Lewis County
West Main Street Complete Streets Project
Lewis County Project No. 5120.8A.25
BCA Project No. 2025-036

Addendum No. 1
April 16, 2026

**WEST MAIN STREET
COMPLETE STREETS
PROJECT**

SHEET NUMBER
TYP-1
CONSTRUCTION DRAWINGS

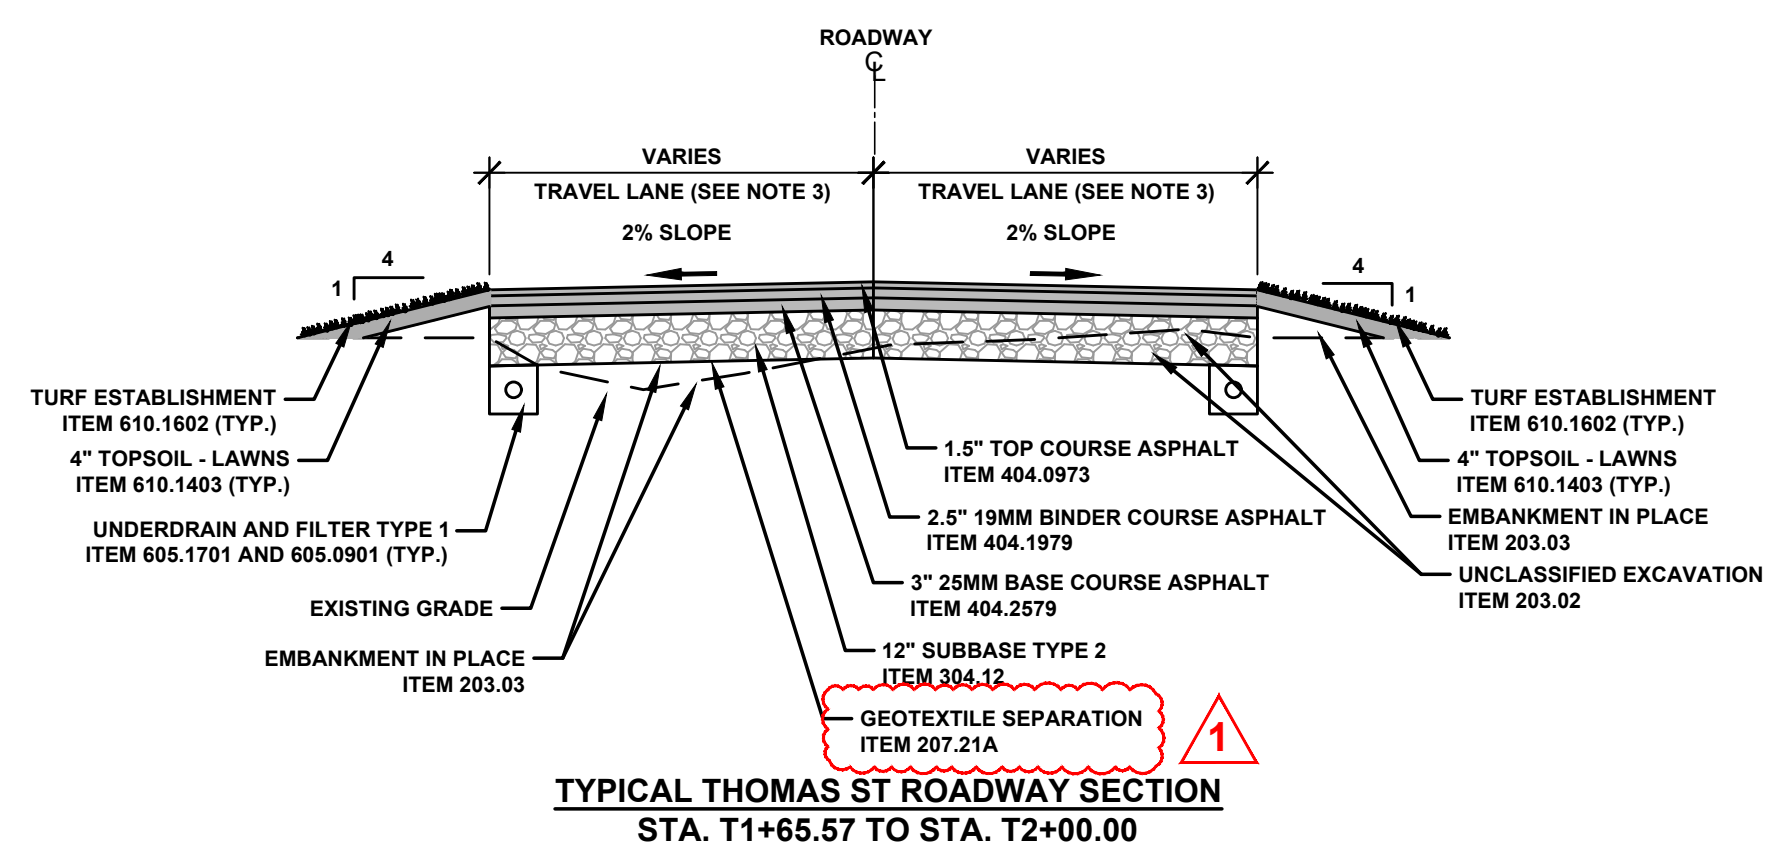
1. **Reference Sheet TYP-2:**
 - A. TYPICAL ROADWAY SECTION – Modify Geotextile Separation pay item from 207.21 to Item 207.21A.
 - B. GRASS AREA SNOW STORAGE – Modify Concrete Sidewalk thickness to 4”

- C. STAMPED CONCRETE SNOW STORAGE – Modify Concrete Sidewalk thickness to 4”
2. **Reference Sheet TYP-2:**
 - A. TYPICAL THOMAS ST ROADWAY SECTION - Modify Geotextile Separation pay item to Item 207.21A.

Addendum 1 (4/16/26): GEOTEXTILE SEPARATION CLARIFICATION AND CONCRETE SIDEWALK THICKNESS

SHEET NUMBER
TYP-2
CONSTRUCTION DRAWINGS

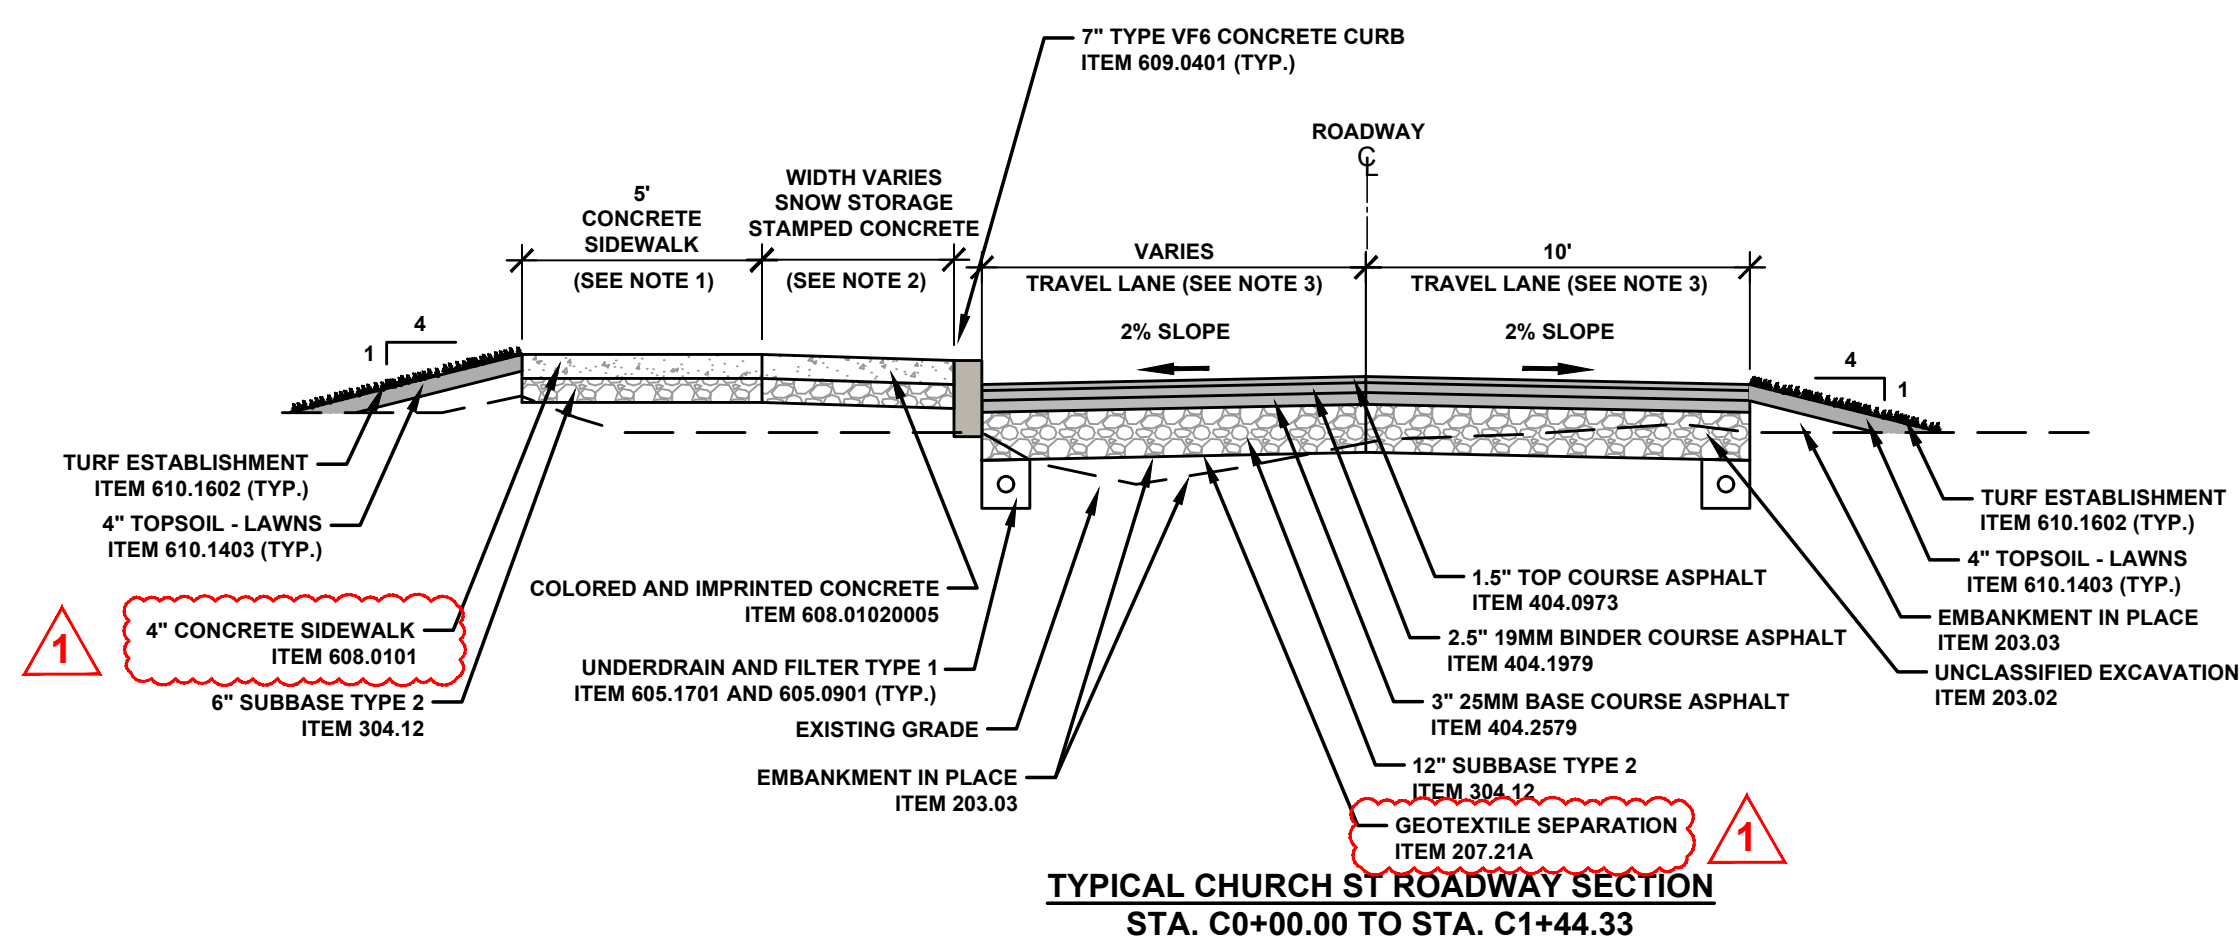
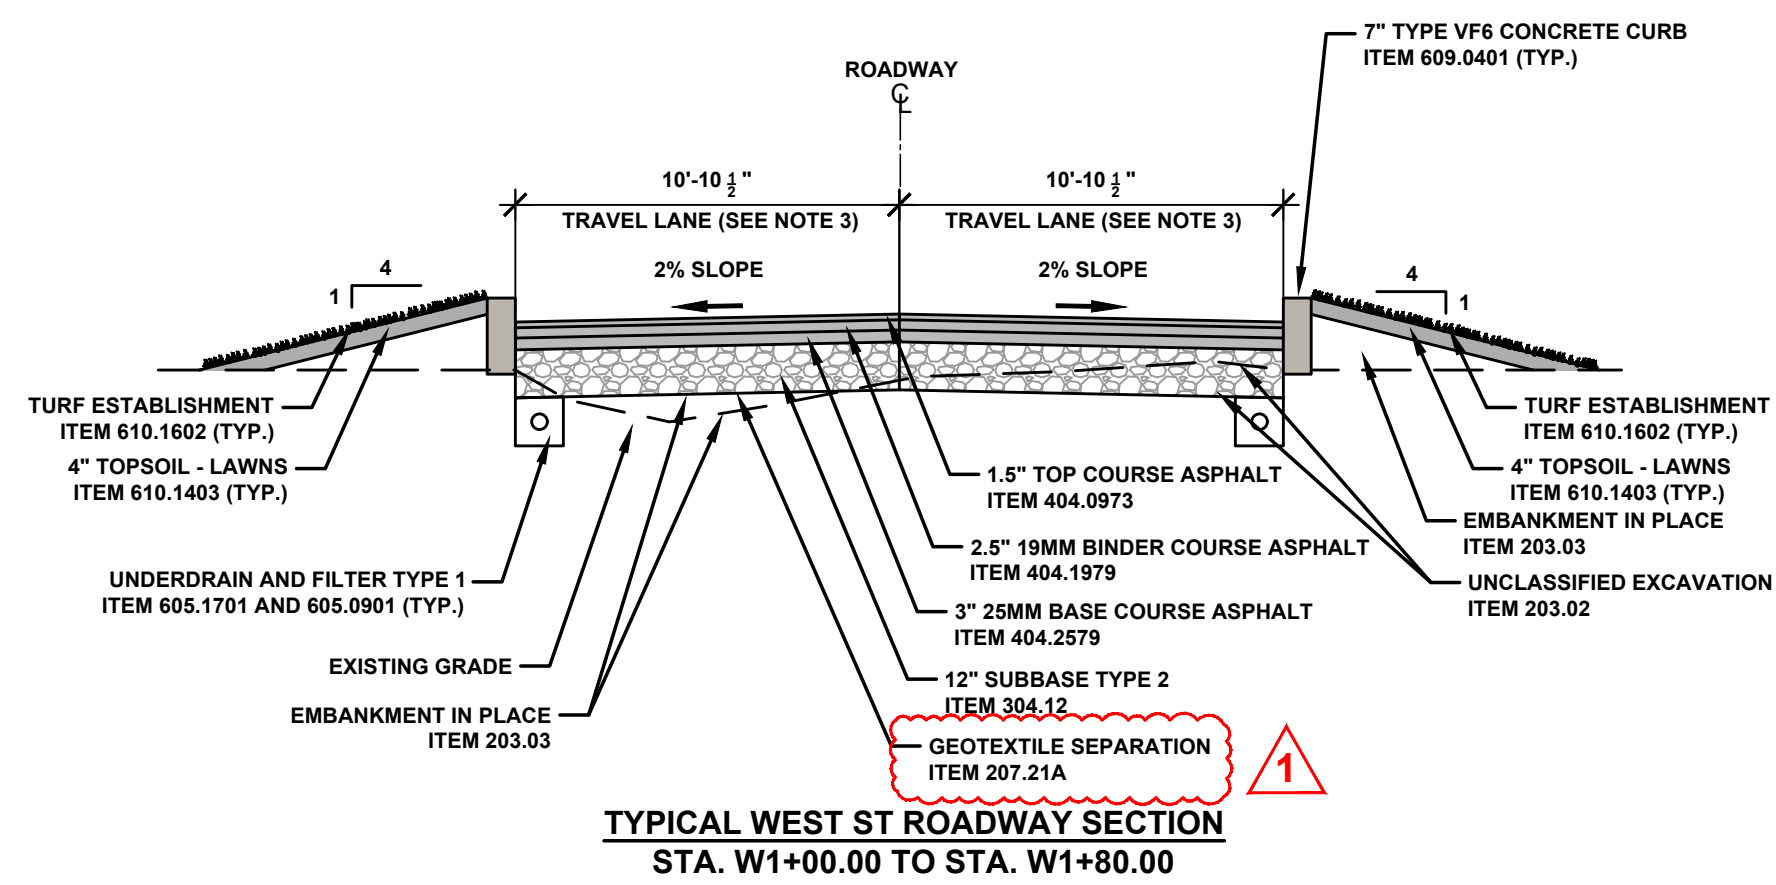
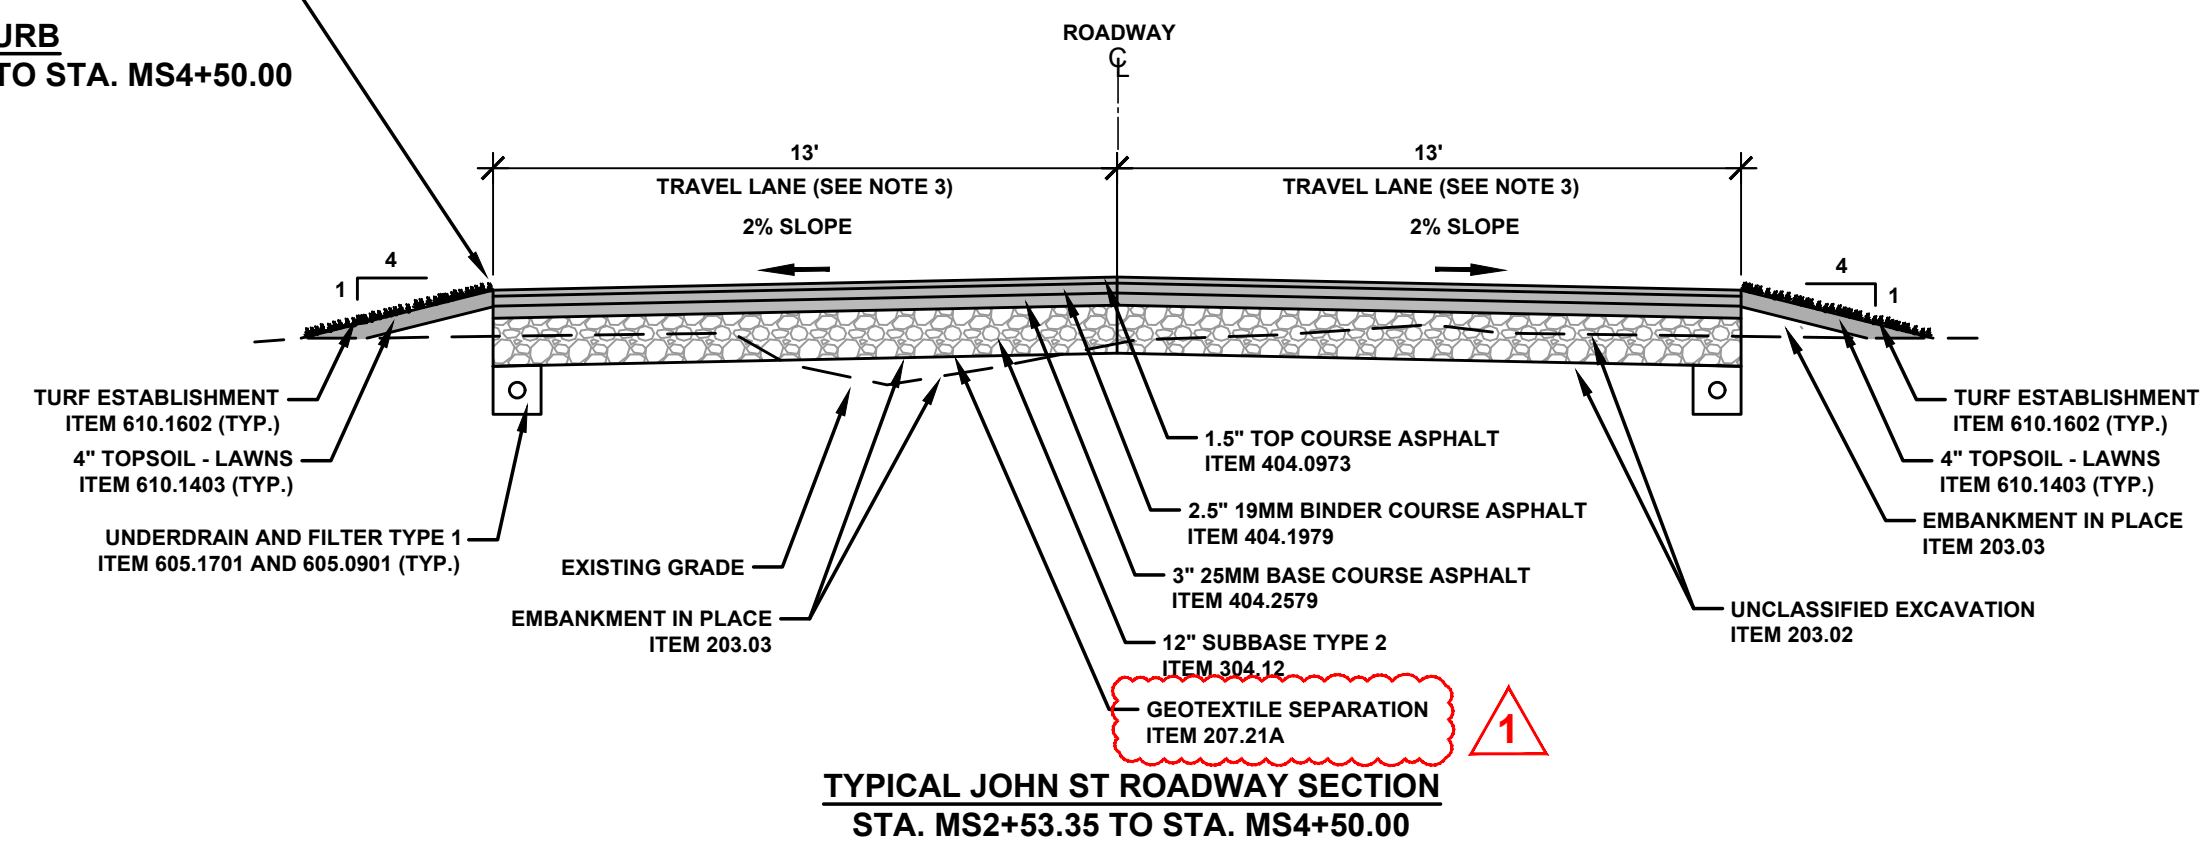
- B. TYPICAL JOHN ST ROADWAY SECTION - Modify Geotextile Separation pay item to Item 207.21A.
 - C. TYPICAL WEST ST ROADWAY SECTION - Modify Geotextile Separation pay item to Item 207.21A.

- D. TYPICAL CHURCH ST ROADWAY SECTION - Modify Geotextile Separation pay item to Item 207.2A and Concrete Sidewalk thickness to 4”.
3. **Reference Sheet MT-1:**

Addendum 1 (4/16/26): GEOTEXTILE SEPARATION CLARIFICATION AND CONCRETE SIDEWALK THICKNESS

SHEET NUMBER
MT-3
CONSTRUCTION DRAWINGS

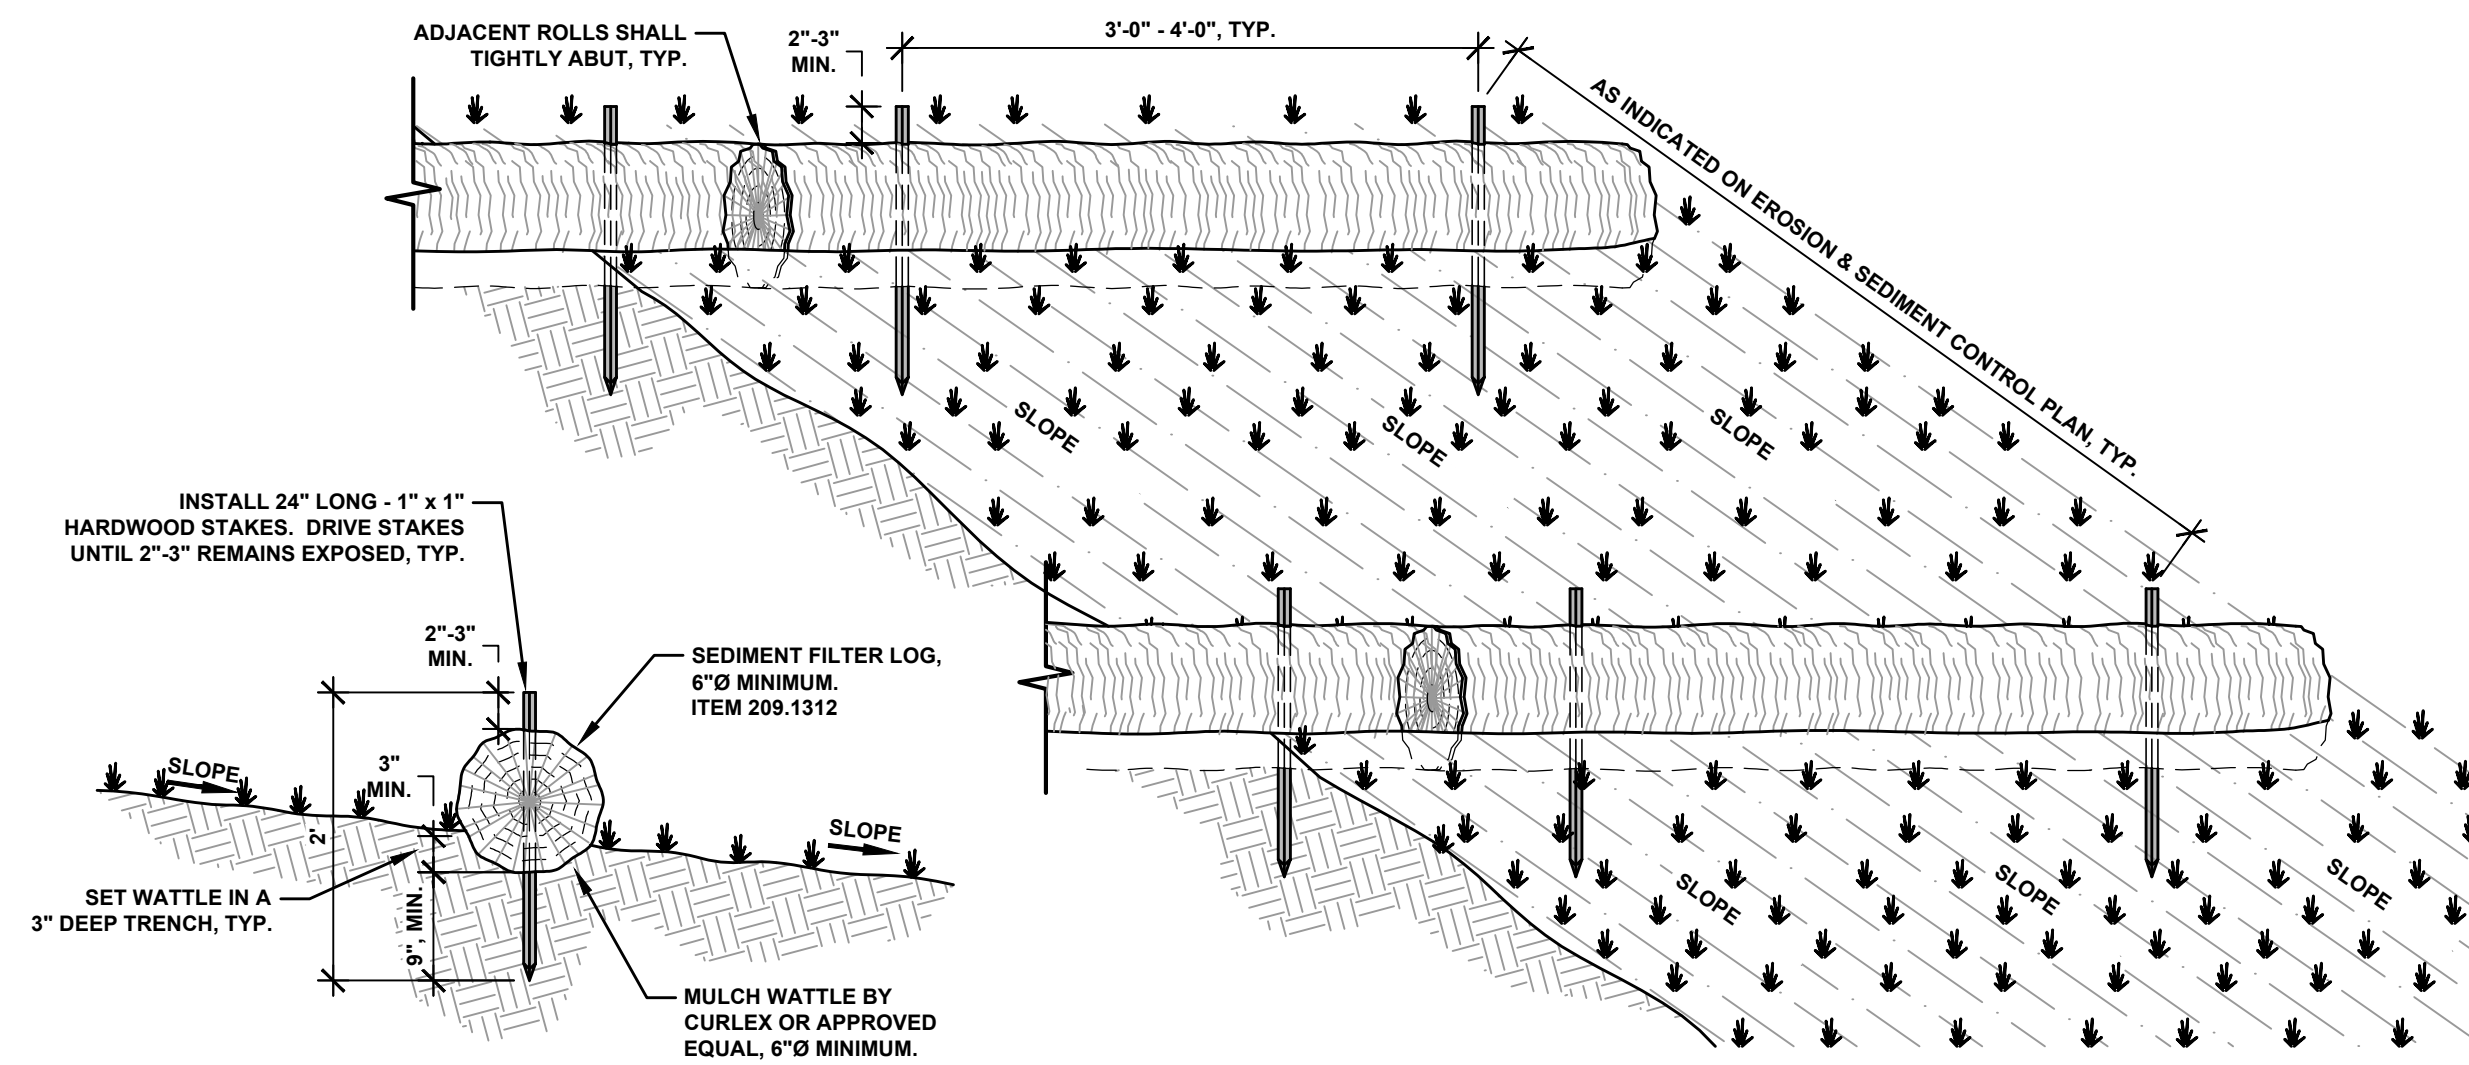
4. **Reference Sheet MT-3:**
 - A. SIDEWALK TABLE (NOT INCLUDING CURB RAMP AREAS) – Modify thickness of concrete sidewalk across driveways to 6”.

Addendum 1 (4/16/26): SIDEWALK THICKNESS AND QUANTITY

RFI ID	Subject	Question	Answer	Closed
0011	Concrete Sidewalk Detail	The table of sidewalks not including curb ramps on plan sheet MT-3 calls out for item 608.0101 crossing driveways to be 5" thickness, but the "Concrete Sidewalk Detail Across Residential and Minor Commercial Driveway" on plan sheet MD-6 calls out item 608.0101 to be installed at 6" thickness. Could you please confirm which depth of installation across residential and minor commercial driveways is correct?	The concrete sidewalk across residential and minor commercial driveways should be 6" thick.	
0012	Drainage Pipe	The utility plans show two runs of 12" SICPP between DS 3-4 to DS 4-2 and DS 4-2 to DS 4-6 that appear to curve, following the alignment of the proposed curb line. Is the intent to use SICPP fittings to make these runs work as designed, we are concerned about the ability to deflect 12" SICPP as currently shown. Please advise.	Please include any fittings, if necessary, in the bid price for Item 603.9812 - 12" SICPP.

0013	Underdrain Excavation	Is the excavation for the proposed 4" underdrain pipe, item 605.1701 included in item 206.0201, trench and culvert excavation?	Per NYSDOT standard sheet 605-02, Underdrain excavation is to be paid by 206.0201 - Trench and Culvert Excavation.	
0014	Stamped Concrete	Are there a stamp pattern and concrete color for item 608.01020005?	An official color and pattern have not been identified prior to bidding. Assume a red herringbone for bidding purposes.	
0015	Concrete Specifications	Will this contract require PEM concrete or are legacy NYSDOT concrete mixes acceptable?	While this project is following the January 2026 NYSDOT specifications, there is not a funding requirement enforcing PEM concrete. Submittals meeting 2024 NYSDOT specifications for concrete will be approved.	
0016	Concrete Sidewalk	Typical section pages (TYP-1 & TYP-2) show both the sidewalks & colored/imprinted PCC to be 6" depth, but the Tables on pages MT-2 & MT-3 show curb ramp locations to be 6" depth, sidewalks to be 4" depth and thru driveways to be 5" depth. Please confirm the proper depth of the concrete sidewalks .	Concrete sidewalk shall be 4" thick, per NYSDOT standard, while concrete sidewalk across driveways shall be 6".
